Investigation Summary Report Update 3

Date: 12 December 2017

Introduction

This investigation is into the activities of heavy vehicle specialist certifier Peter Wastney and was initiated following a crash on 27 August 2017, where the catastrophic failure of a drawbeam on a truck JWN197 resulted in the detached trailer travelling a significant distance before coming to rest against a bank.

Figure 12 Burrs on right-hand side plate, top front bolt hole

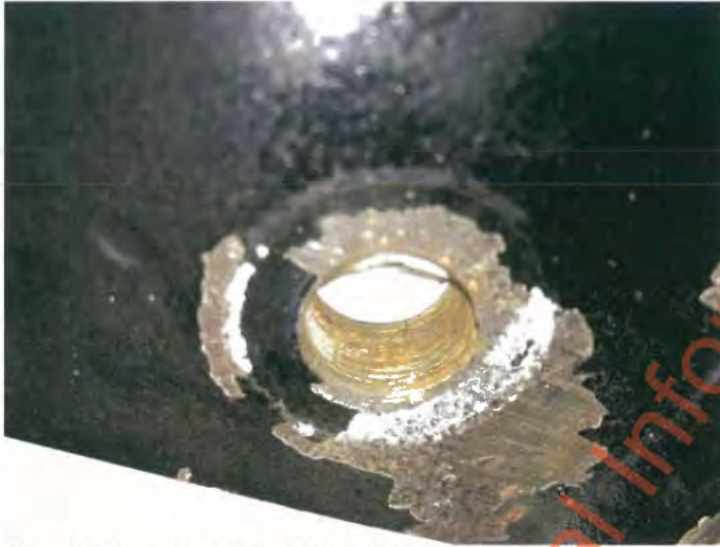
Most holes on the inside face of the side plates had burrs on their edges, Figure 12 and Figure 13.

Figure 17 Side plate fatigue progression and initiation point (red circle)

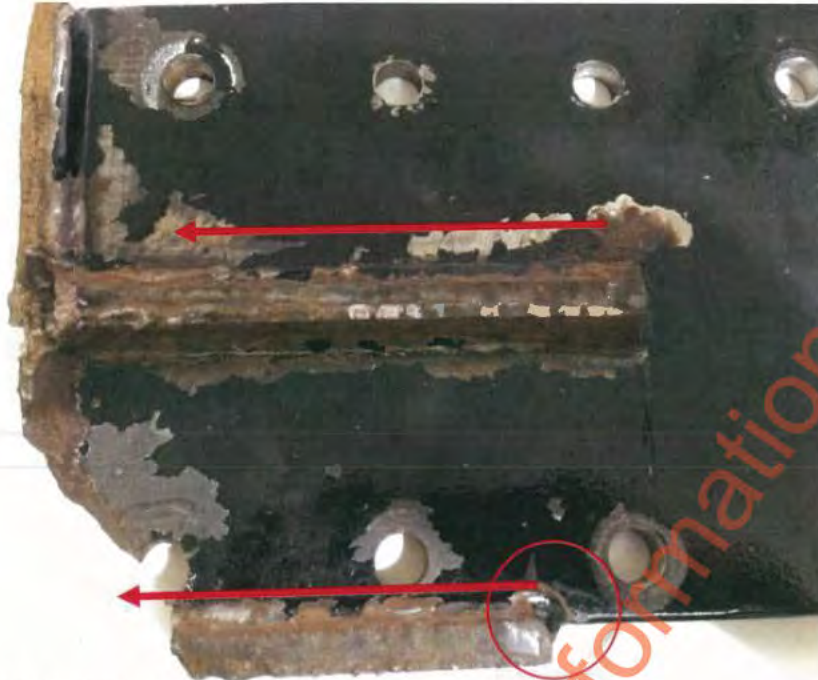
Evidence of fatigue in the drawbeam weldment was found (Figure 17). The fracture between the upper and lower stiffeners and side plate has occurred at the base of the weld toe in the parent metal; this is a typical area for crack initiation and propagation (Hobbacher, 2006). The crack initiation point seems to be located at the rear bottom stiffener plate, refer Figure 17 and Figure 18.

Figure 31 von Mises stress, drawbeam 260kN load, areas in grey exceed 250 MPa

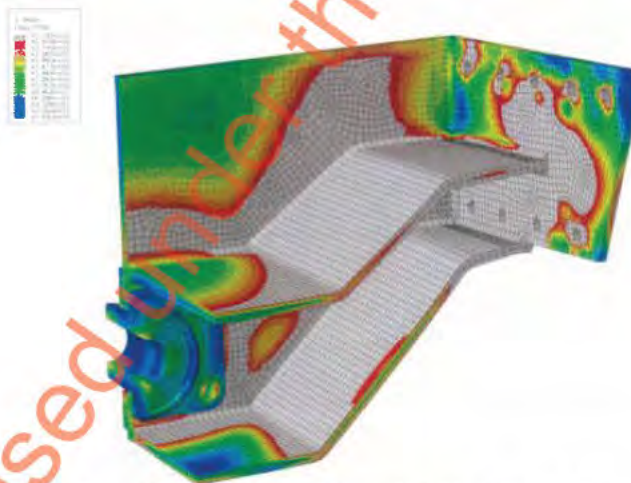
A 260kN load (for a 30,000kg MTM trailer) is applied to the Ringfeder attachment. The applied load caused large areas of the drawbeam to exceed the material yield stress, Figure 31.

The drawbeam does not comply with the requirements of NZS 5446 for static longitudinal loading. The stress in the drawbeam should not exceed 150 MPa and or show any yielding (plasticity).

Figure 32 von Mises stress, drawbeam 260kN load, areas in grey exceed 150 MPa

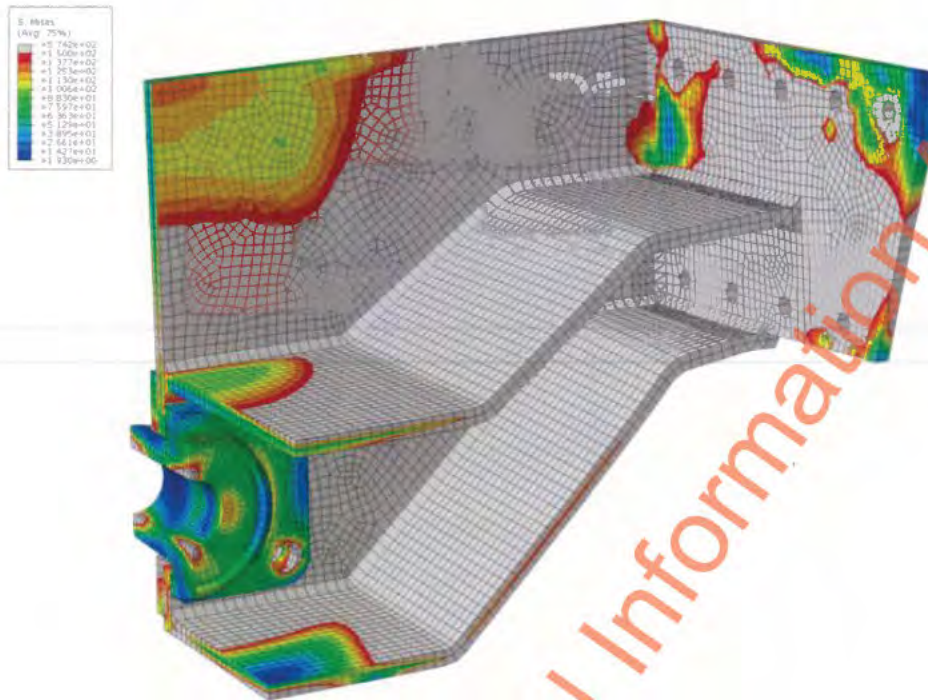
Large areas also exceed the maximum permissible stress of 150 MPa, Figure 32.

Figure 33 Areas showing plasticity after removal of load (colour other than indicator)

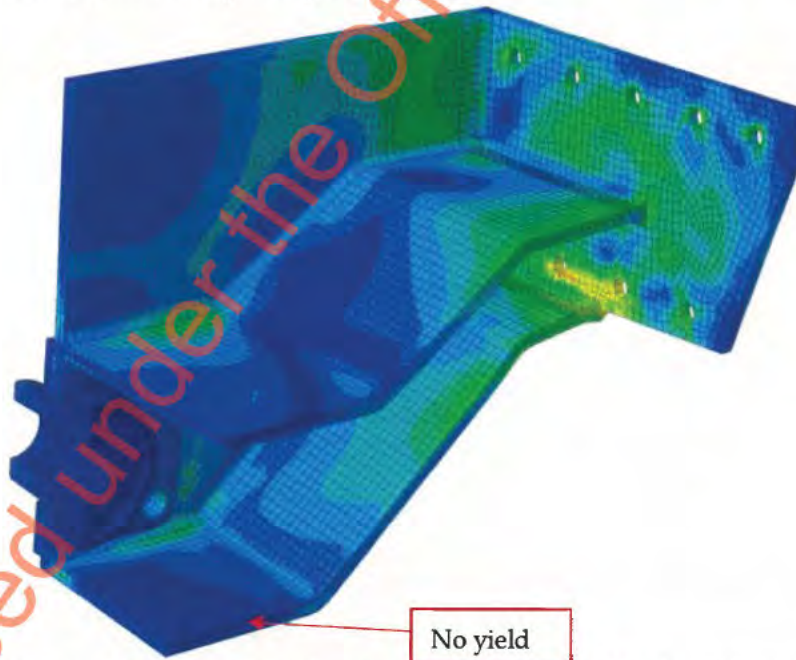
After load removal, the finite element analysis showed areas of the drawbeam had permanent deformation (plastic yield).

Figure 43 Certifiers drawbeam analysis - 220kN

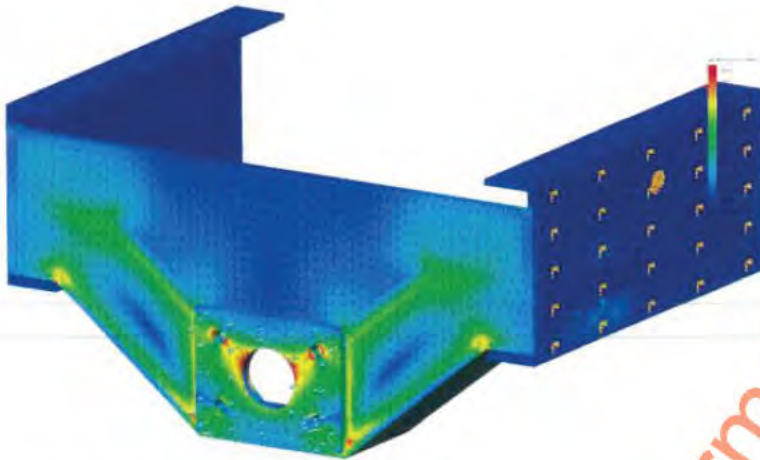
Sandbox Consulting ran the certifiers FEA model using Solidworks 2017 simulation.

It is notable that the certifiers FEA results show stress levels which significantly exceed the material yield stress. The certifiers model shows the drawbeam does not comply.

Figure 44 Certifiers drawbeam analysis - 220kN, rear view

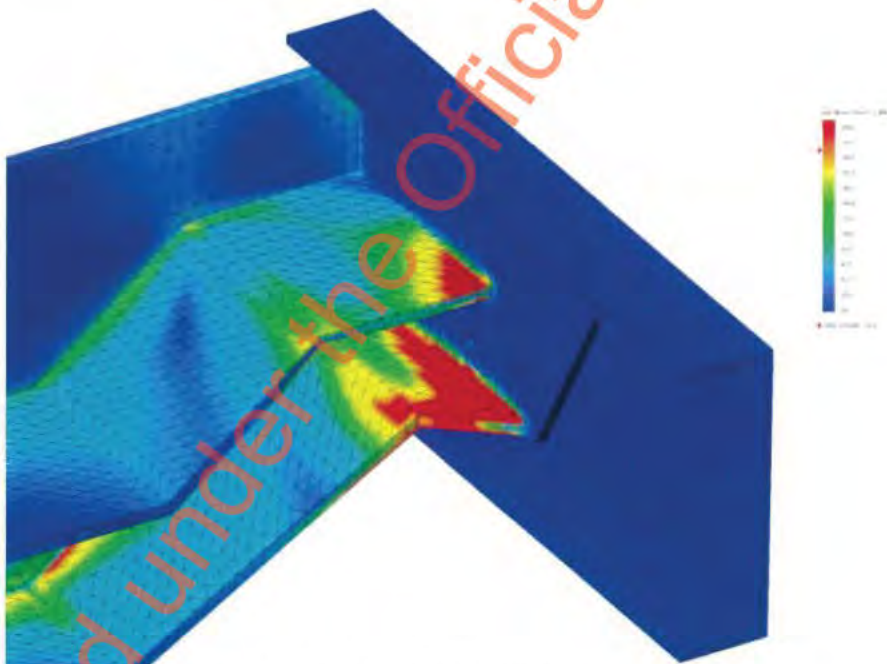
Refinement of the finite element mesh was carried out in order to improve the accuracy of the results; this is good practice. Mesh improvement and convergence studies are an important part of validating FEA.

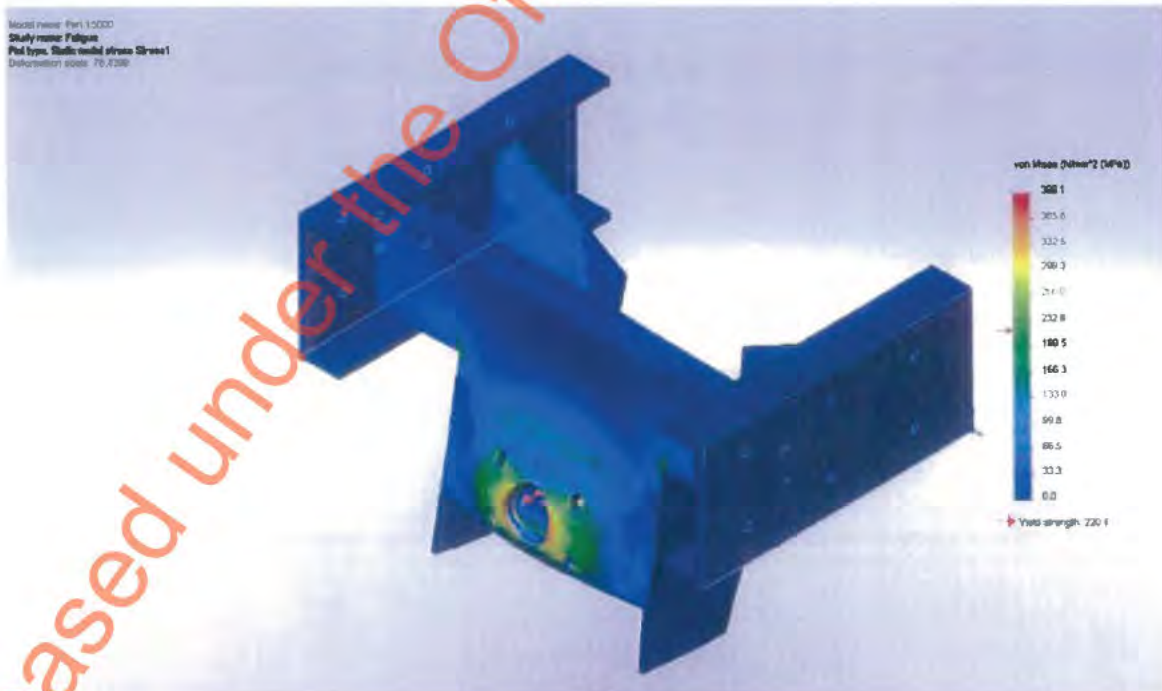
The information provided to support your certification decision is inadequate; on what basis did you determine that the drawbeam meets NZS 5446?

In particular the image below is from your certification file for LT400 348824. For fatigue compliance stress should be no more than 60% of yield strength according to AS 3990, however the FEA image shows stress levels above yield. Is this correct, and if so why did you proceed to certify the drawbeam?

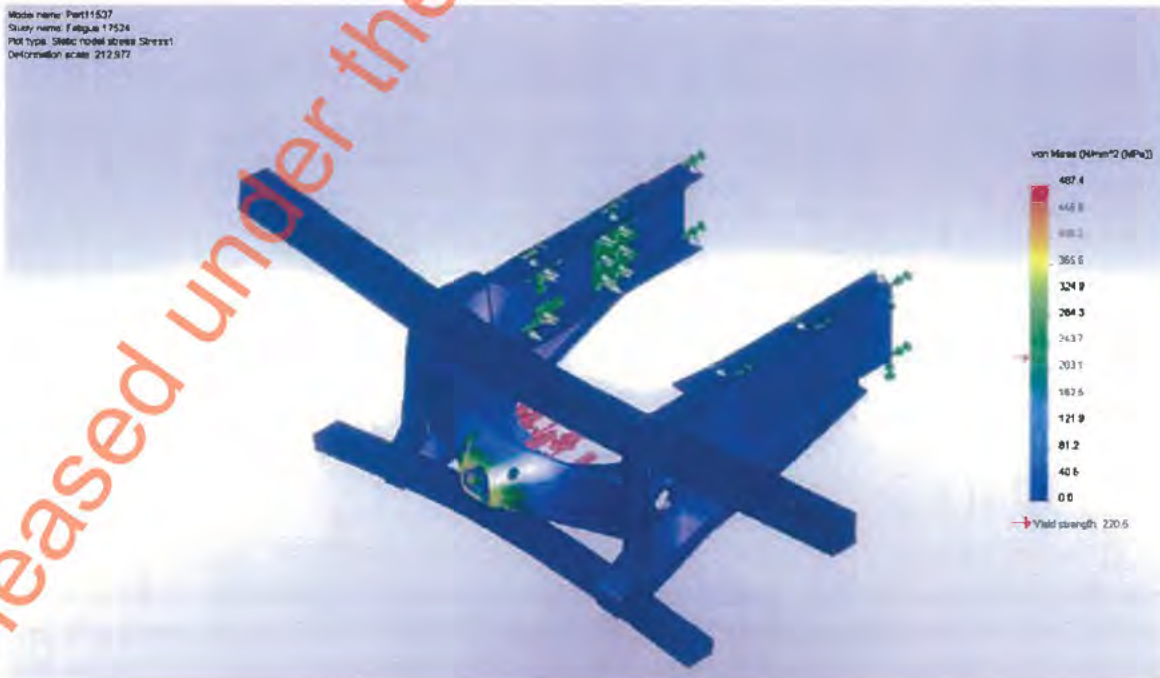
The information provided to support your certification decision is inadequate; on what basis did you determine that the drawbeam meets NZS 5446?

In particular the image below is from your certification file for LT400 476767. According to AS 3990, for fatigue compliance stress should be no more than 60% of yield strength, however the FEA image shows stress levels above yield. Is this correct, and if so why did you proceed to certify the drawbeam?

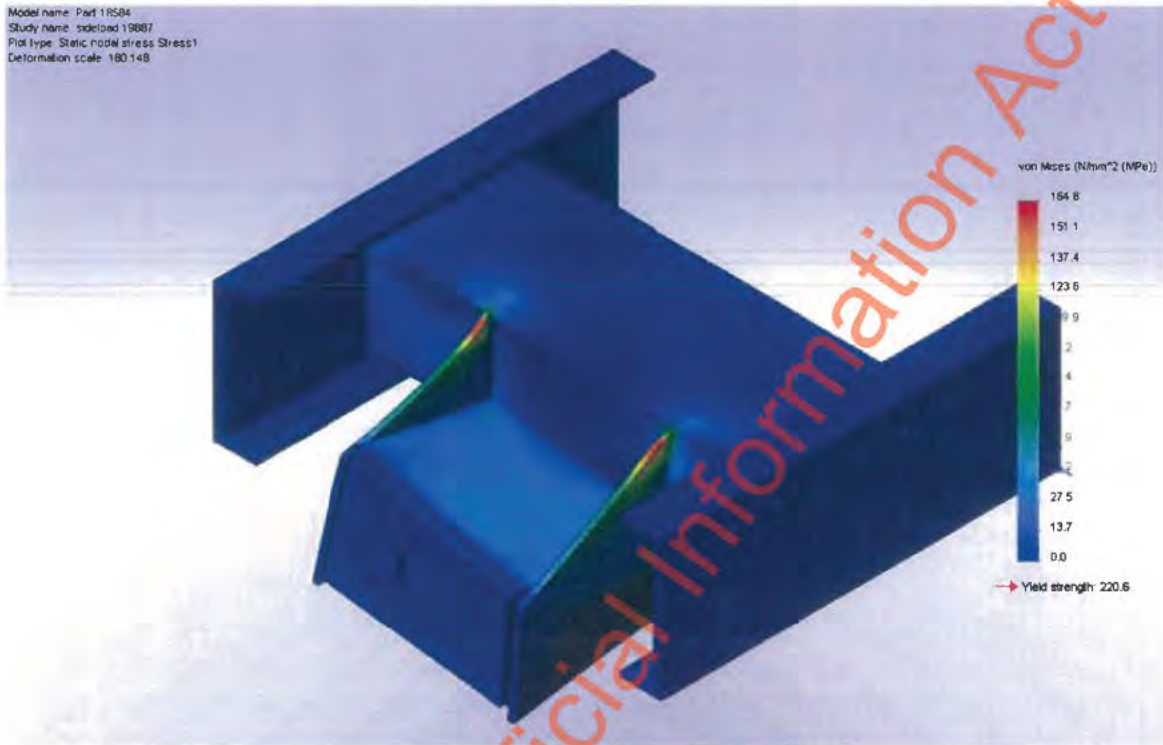
- No photos of drawbeam fitted to vehicle - bolted connections or welds.
- No confirmation that correct bolts/washers were used.
- No drawbeam calculations.
- No vehicle layout drawing - to confirm legal position.
- No FEA validation calculations/justification.
- No loading data - NZS 5446.
- No bolt load analysis.
- No weld analysis.
- FEA analysis
 - Inappropriate boundary conditions.
 - Poor mesh.
 - Artificial reinforcing of plates.
 - Insufficient detailing to allow weld analysis from FEA results.
 - Fatigue analysis not included in provided CAD file, pictures provided later
 - No static longitudinal load in FEA file initially provided, pictures provided later

In particular the image below is from your certification file for LT400 607095. For fatigue compliance stress should be no more than 60% of yield strength according to AS 3990. For a yield strength of 220MPa that would be 132MPa, however the FEA image shows stress levels above this – in the region of 150MPa. Is this correct, and if so why did you proceed to certify the drawbeam?

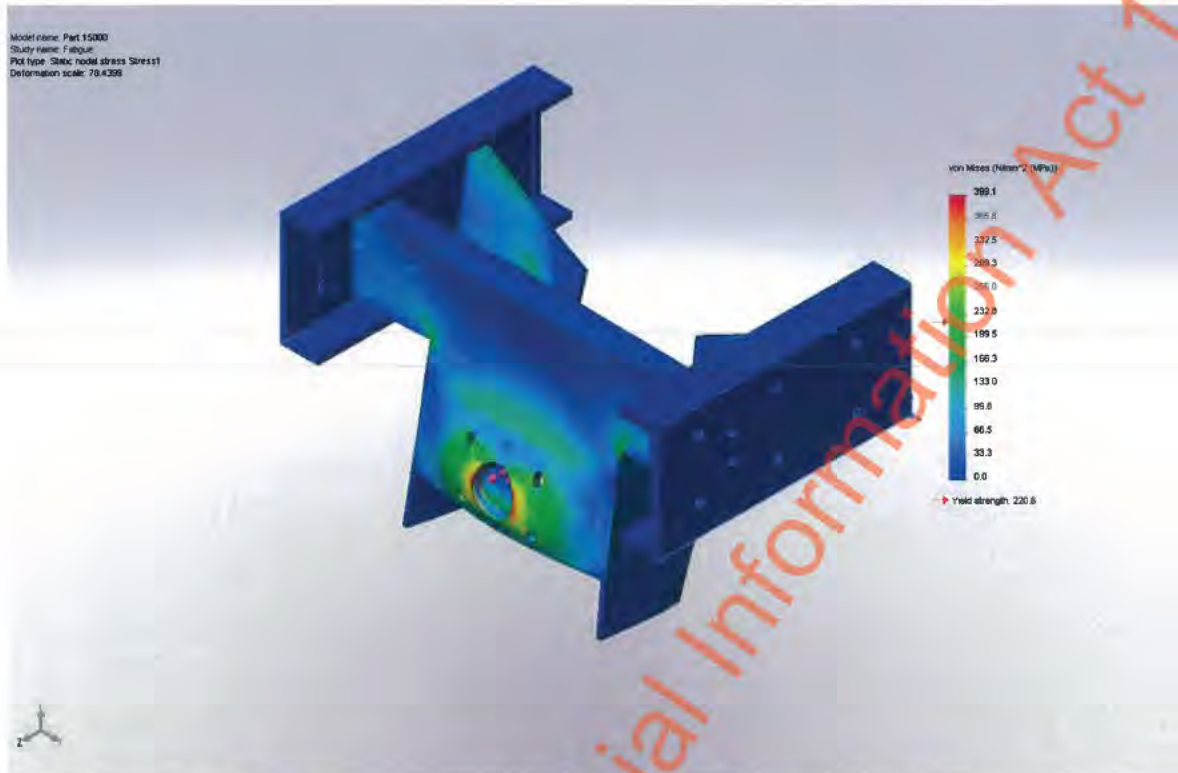
No Bolt Load Analysis.

Bolt Load analysis is held on a separate Excel file to the main certification documents supplied to you, and was not included. This analysis is now attached.

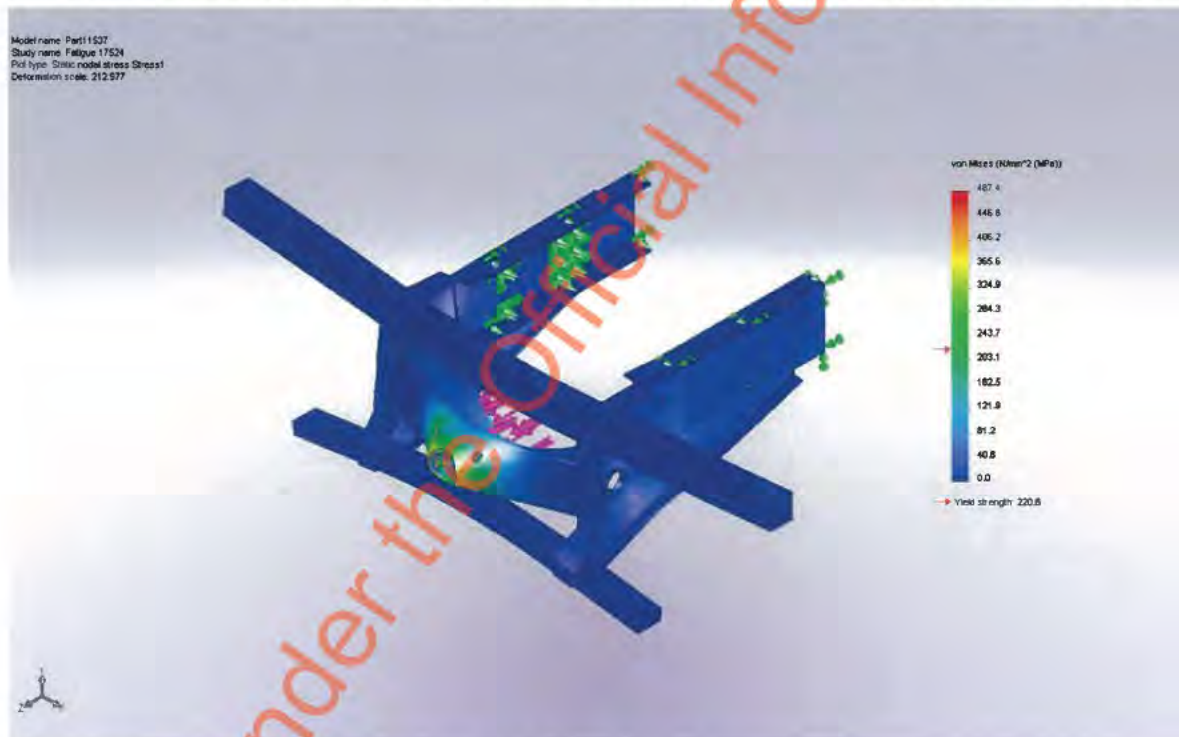
No Bolt Load Analysis.

Bolt Load analysis was overlooked for this mounting, but with 12 pair of 16⁺ bolts over a 644mm x 130mm pattern is known to be well within requirements..

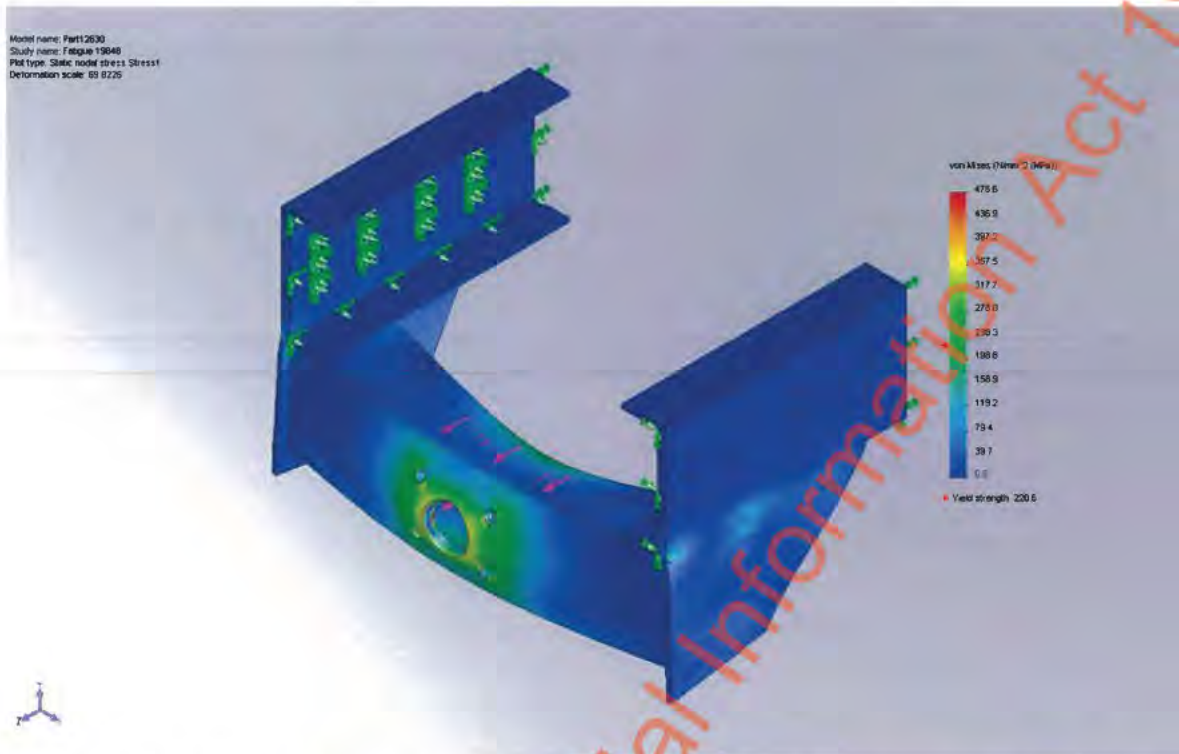
No Bolt Load Analysis.

Bolt Load analysis is held on a separate Excel file to the main certification documents supplied to you, and was not included. This analysis is now attached.

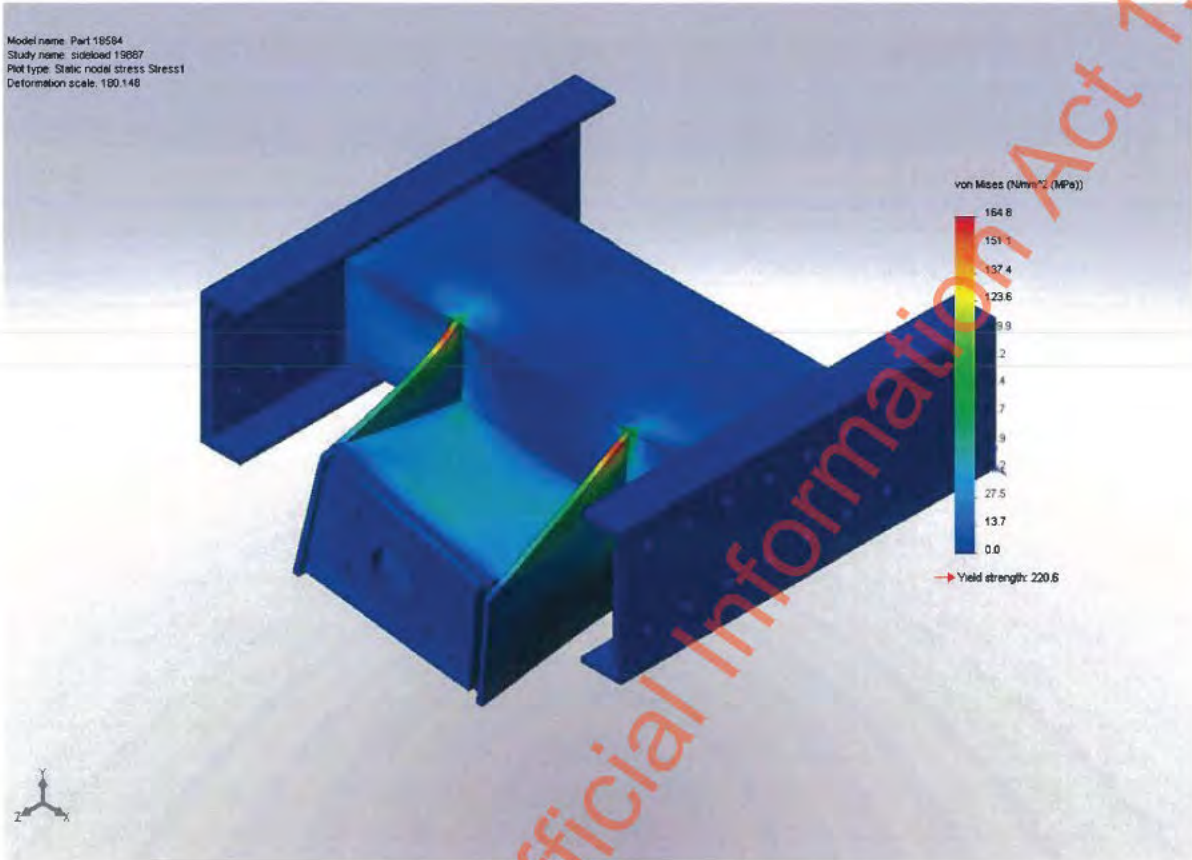
You raised the query on the Side Load Analysis on the above drawbeam, noting in the attached Diagram that the analysed stress was 165 mPa, higher than the 60% of yield for 220 mPa material.

This plot shows the loading as prescribed by NZS 5446 applied to the area bounded by the towing coupling flanges. This is not quite correct, as this area is clamped by the flanges. A more representative result would be obtained by applying this load as a rigidly applied load, or by modelling the actual coupling onto the drawbeam. However, both of these methods have drawbacks. It can be shown that so long as the section being bolted through is at least 16mm thick, there is no problem in the section of the drawbeam contained within the coupling flange meeting NZS 5446 loading. In analysing this plot, therefore, the stresses bounded by the coupling flange may be ignored. In this case, it can be seen that drawbeam stresses are actually within the 60% threshold of Yield Stress.

This was in small surface areas of the Gussets. Although the analysis was carried out for 220 mPa yield, manufacture for this new drawbeam was from 300 mPa Yield plate, so this design was accepted as being within the allowable limits.
